Office Action Summary

10/696,525

DETAILED ACTION

Figure 1 (Prior Art)

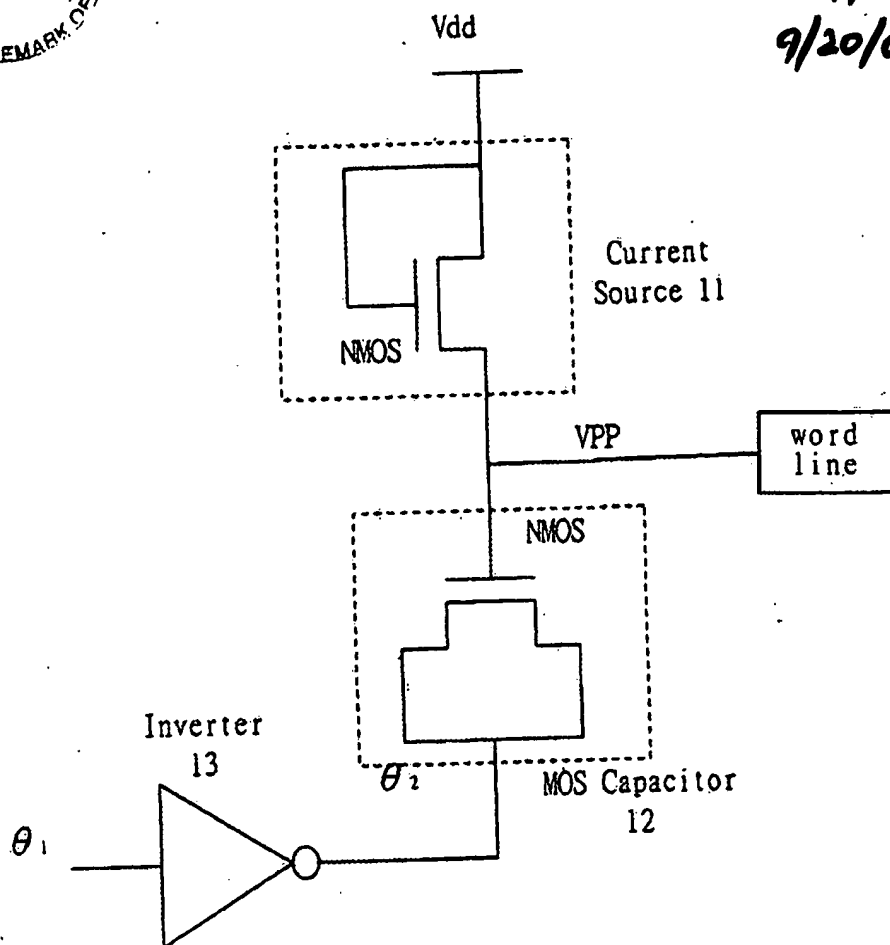
4. Claims 1-13 are, insofar as understood, rejected under 35 U.S.C. 103(a) as being unpatentable over Applicant's Fig. 1 Prior Art, in view of Selcuk et al., 5,879,980, and Hiratsuka et al., 5,453,707.

What is not shown in Applicant's Fig. 1 Prior Art is the storage cell.

It would have been obvious under 35 USC 103(a) to one of ordinary skill in the art at the time of the invention was made to serially connect a capacitor 40/42 in Fig. 1 of Selcuk et al., 5,879,980, between the output of inverter I3 and MOS capacitor 12 in Applicant's Fig. 1 Prior Art for the purpose of enhancing the capacitance to increase the stability and noise immunity of the memory cell (see lines 4-9, column 5 of Selcuk et al., 5,879,980).

What is not shown in Applicant's Fig. 1 Prior Art, which is modified by Selcuk et al., 5,879,980, is the driving circuit consists of a PMOS transistor and a NMOS transistor generating a first clock signal according to a second clock signal and a third clock signal.

It would have been obvious under 35 USC 103(a) to one of ordinary skill in the art at the time of the invention was made to utilize the CMOS inverter 18 in Figs. 4-5 of Hiratsuka et al., 5,453,707, for the inverter I3 in Applicant's Fig. 1 Prior Art, which is modified by Selcuk et al., 5,879,980, for the purpose of reducing power dissipation and preventing power source noise and ground noise (see lines 43-49, column 3 of Hiratsuka et al., 5,453,707).

Figure 2(A)

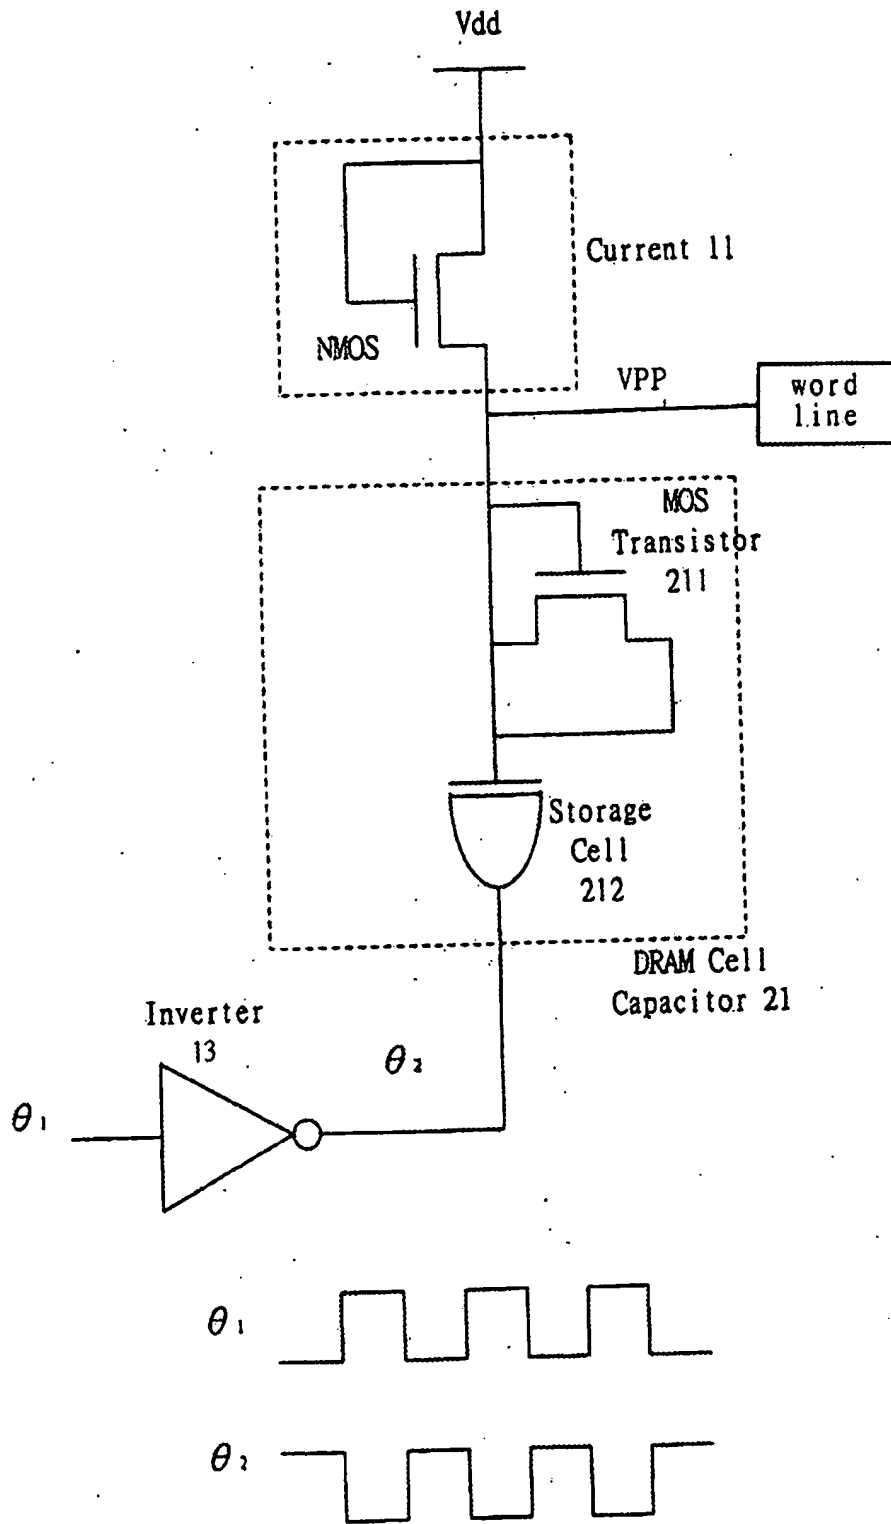
It is not understood what type of storage cell 212 in Figs. 2(A) and 2(B) really is. Is it whether a memory cell, a capacitor, a transistor or what else?
